14MP
14 Milton Place
Gravesend
DA12 2BT
Kent

Interior refurbishment
Listed Building Consent 20250269

Details showing how the insulation boards will be installed in relation to the skirting boards and architraves.
Sash windows with architrave:
-Bedroom 1, 2, 3, 4
-Kitchen
-Reception room

14MP09/PR	Rev.3
Status: Discharge of planning conditions	
25-06-2025	1:2 and 1:10@A3

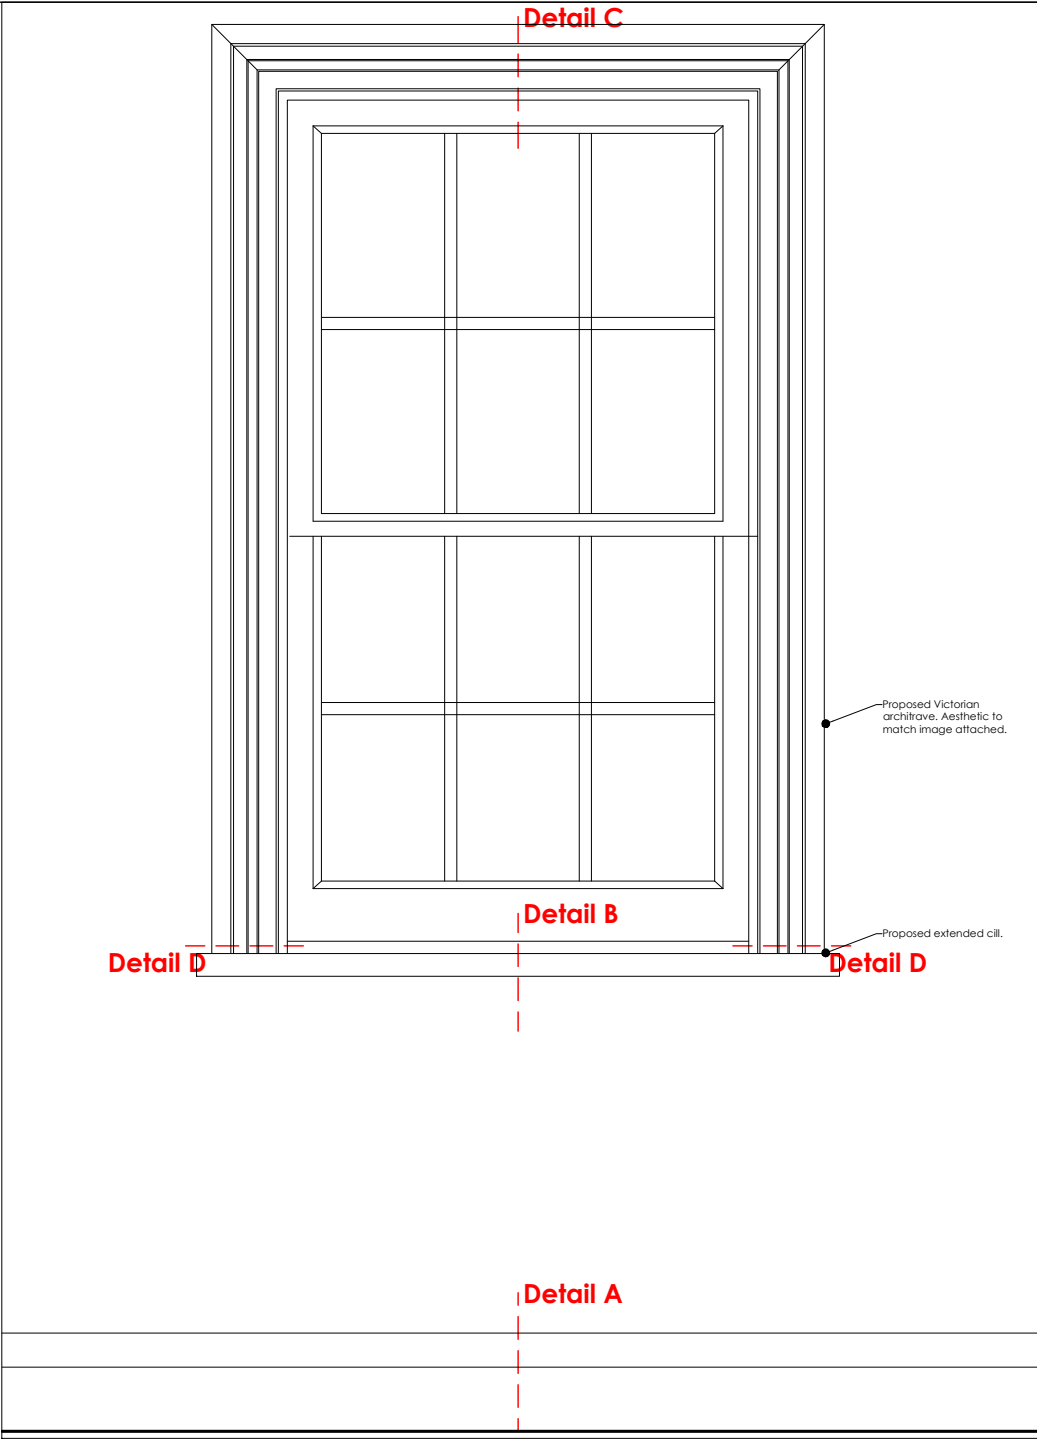
10/07/2025 - Rev.1
-Window's reveals adjusted by extending the window cill and reveal board with an Victorian architrave.
-Proposed new Victorian skirting board , as per planners' suggestion.

23/07/2025 - Rev.2
-Windows architraves' setting amended as per planners' request.
Architrave to be added also to Bedroom 2, 4 and Reception room.

01/08/2025 - Rev.3
-Windows details amended to reflect existing section.
-Secondary glazing details and notes for reference.
